**FORMER POULTRY FARM,
SILVER BIRCH DRIVE, YAPTON**

PROPOSED HIGHWAY ACCESS

**STAGE 1
ROAD SAFETY AUDIT REPORT**

RKS Associates Ref: VRP1110-01

Appendix A

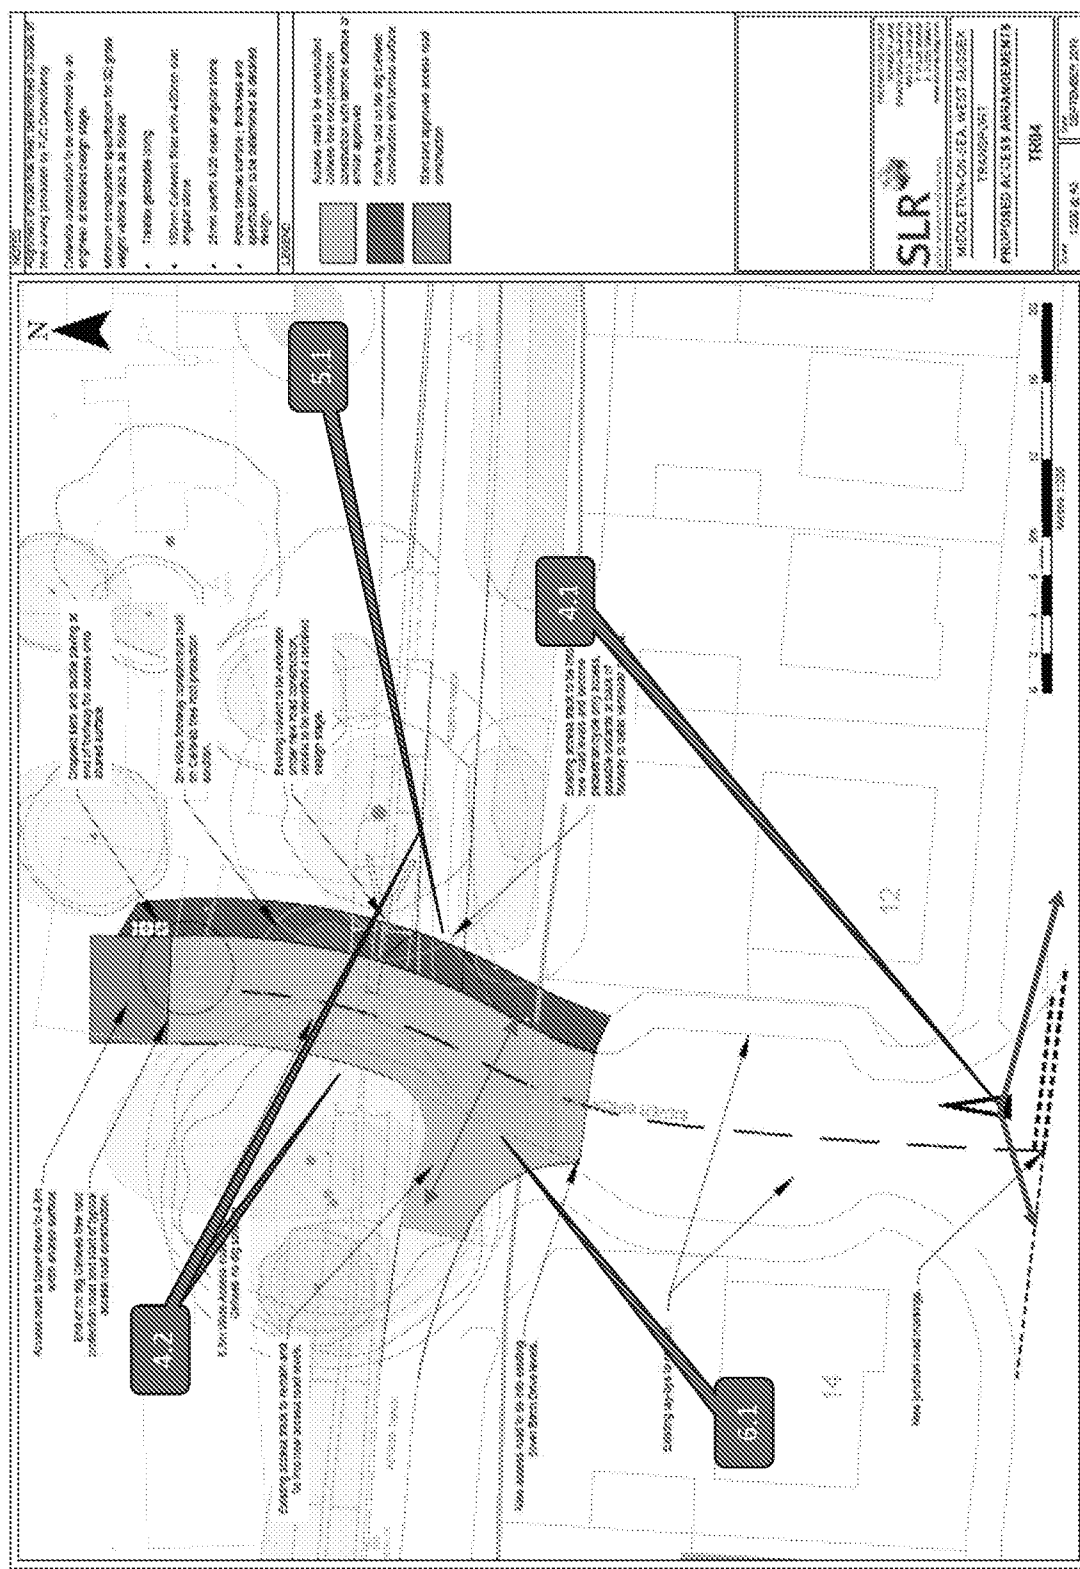
Summary: Potential collisions due to standing water or service covers

Location: *throughout*

No details have been provided in respect of surface water drainage or other services and it is therefore not possible to ascertain whether or not there will be any safety implications.

Ensure adequate surface water drainage is provided, gullies/service covers should be kept clear of desire lines for pedestrians and cyclists.

Summary: Potential vehicle turning collisions associated with poor visibility

Location: *Proposed egress onto Silver Birch Drive*

No details of visibility splays have been provided, it is therefore not possible to ascertain whether or not there will be any safety implications. However, observations during the site inspection noted vehicles parked along Silver Birch Drive adjacent to the cul-de-sac (outside Number 12) may restrict visibility for vehicles exiting out onto Silver Birch Drive. There is concern poor visibility may increase the risk of turning collisions between vehicles exiting the development and traffic traveling along Silver Birch Drive.

Ensure that visibility splays to and from the proposed access road (cul-de-sac) are provided, if necessary additional measure to prevent obstruction in visibility should be provided.

Summary: Potential vehicle turning collisions associated with poor visibility

Location: *Access track junction proposed continuation of cul-de-sac*

No details relating to the boundary treatment between the access track to the rear of properties fronting Silver Birch Drive and the access road serving the development have been provided. There is concern that inappropriate boundary treatment may restrict visibility to and from the access track and traffic traveling along the access road. Poor visibility may increase the risk of collisions between road users of the Access Track and traffic accessing the proposed development.

Ensure that a suitable boundary treatment that provides sufficient visibility splays between the Access Track and the proposed development access are provided.

Summary: Potential risk of pedestrian injury

Location: *Proposed extension of pedestrian footway into development and adjacent culvert*

The scheme proposals indicate that pedestrian footway along the eastern side of the cul-de-sac is to be extended into the development and that a new culvert is to be provided between the development and the public right of way. The absence of suitable protection between the footway and culvert may increase the risk of injury to pedestrians who may inadvertently veer off the footway and fall into the culvert.

Suitable protection between the proposed footway and culvert should be provided.

Summary: Potential risk of collisions associated with failing to give way

Location: Access track junction with development access road

The scheme proposals indicate that vehicle track running behind the properties fronting Silver Birch Drive will meet the development access road at a priority junction. However, the absence of appropriate carriageway markings may increase the risk of collisions between traffic entering and traveling along the development access road.

Ensure that carriageway markings or signs are provided to inform motorists of the priority at the junction.

Item No.	Audit Team Recommendation(s)	Designer's Response
3.1	Ensure adequate surface water drainage is provided, gullies/service covers should be kept clear of desire lines for pedestrians and cyclists.	Agreed. This will be considered within the detailed design stage. A note has been added to the drawing (Rev A).

4.1	Ensure that visibility splays to and from the proposed access road (cul-de-sac) are provided, if necessary additional measure to prevent obstruction in visibility should be provided.	Visibility in both directions is adequate and in accordance with the standards stated within the Manual for Streets. The recorded accident data does not include any incidents at this junction. A note on visibility has now been included on the drawing (Rev A).

4.2	Ensure that a suitable boundary treatment that provides sufficient visibility splays between the Access Track and the proposed development access are provided.	Vegetation will be cut back to provide adequate pedestrian to pedestrian/cycle visibility. A note on has been added to the drawing (Rev A).

5.1	Suitable protection between the proposed footway and culvert should be provided.	Agreed. This will be considered within the detailed design stage. A note has been added to the drawing (Rev A).

6.1	Ensure that carriageway markings or signs are provided to inform motorists of the priority at the junction.	A brick/block threshold or road marking will be provided indicating priority. This will be determined during the detailed design stages. A note has been added to the drawing (Rev A).
